# UNITED STATES PATENT AND TRADEMARK OFFICE

APPLICATION NO.	FILING DATE	FIRST NAMED INVENTOR	ATTORNEY DOCKET NO.	CONFIRMATION NO.
10/786,184	02/25/2004	Robert D. Dressler		3695

**Office Action Summary**

## DETAILED ACTION

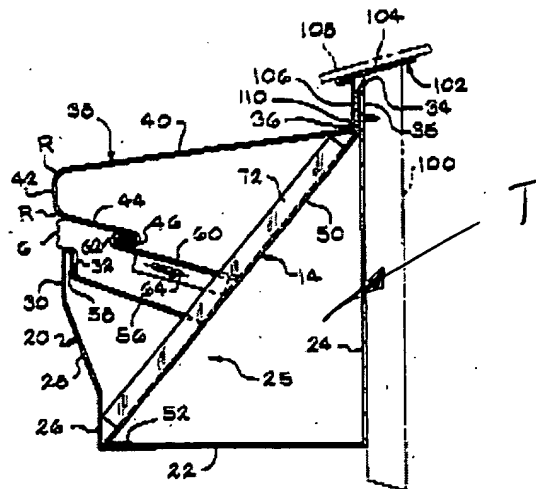
Claims 2 and 13 are rejected under 35 U.S.C. 102(b) as being anticipated by US Patent #5,737,879 to SWEET. SWEET discloses the use of a rain gutter (10) having a generally open top and including a trough portion (T) having a front face (20) with an upper lip (32), a rear wall (12), and a bottom wall (22); an integral leaf guard portion (38) extending from the rear wall (12) and terminating in an attachment lip (46) proximate the upper lip (32); a connecting member (14) that interengages the attachment lip (46) and the upper lip (32); and a mounting flange formed by an extension (35) of the rear wall (12) above the upper lip (32) and a leg (36) of the leaf guard (38) that is oriented parallel to the rear wall (12) by being bent 180 degrees therefrom.

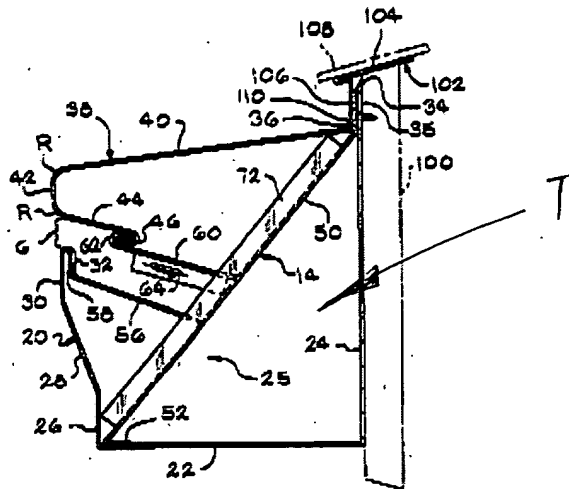
Claims 8 and 9 are rejected under 35 U.S.C. 102(b) as being anticipated by US Patent #5,737,879 to SWEET. SWEET discloses the use of a rain gutter (10) having a generally open top and including a trough portion (T) having a front face (20) with an upper lip (32), a rear wall (12), and a bottom wall (22); an integral leaf guard portion (38) extending from the rear wall (12) to the upper lip (32) to close the top of the trough (T); wherein the leaf guard (38) includes a body (40) that extends generally perpendicular to a leg member (44) that terminates in an attachment lip (46) proximate the upper lip (32) by connecting member (14). Regarding claim 9, the rear wall (12) includes an extension (35) that projects vertically above the upper lip (32) such that the rear wall

extension (35), and the leg member (36) form a mounting flange for engagement with a fastener (110) that connects the mounting flange (35,36 combined) to a support structure (100) on which the gutter (10) is mounted.

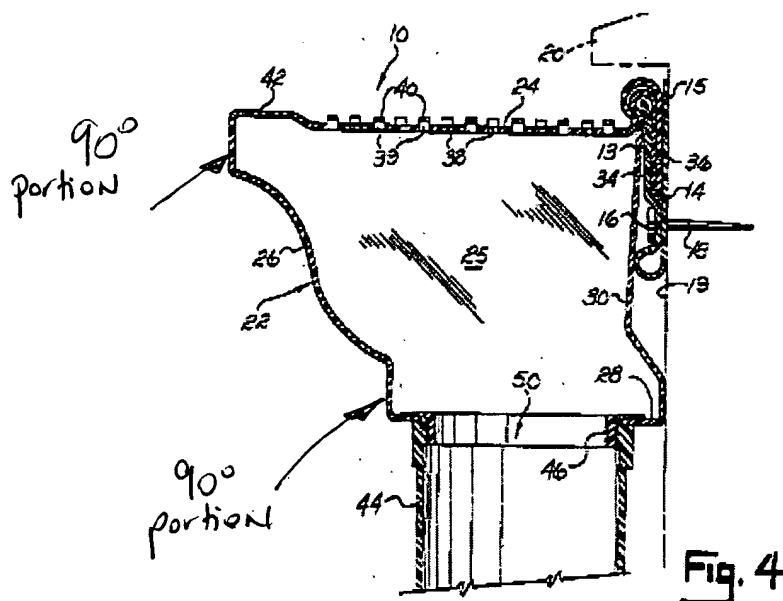
Claim 11 is rejected under 35 U.S.C. 103(a) as being unpatentable over US Patent #5,737,879 to SWEET in view of US Patent #4,727,689 to BOSLER. SWEET discloses the basic claimed rain gutter except for the use of a scalloped shaped curved front face. BOSLER teaches that it is known in the art to provide the front face (22) with a scalloped portion (26) positioned between spaced apart ninety degree bends (see below). Thus, it would have been obvious to one having ordinary skill in the art at the

time the invention was made to provide the front face of SWEET with the scalloped face of BOSLER in order to have a gutter that is decorative and aesthetically pleasing.
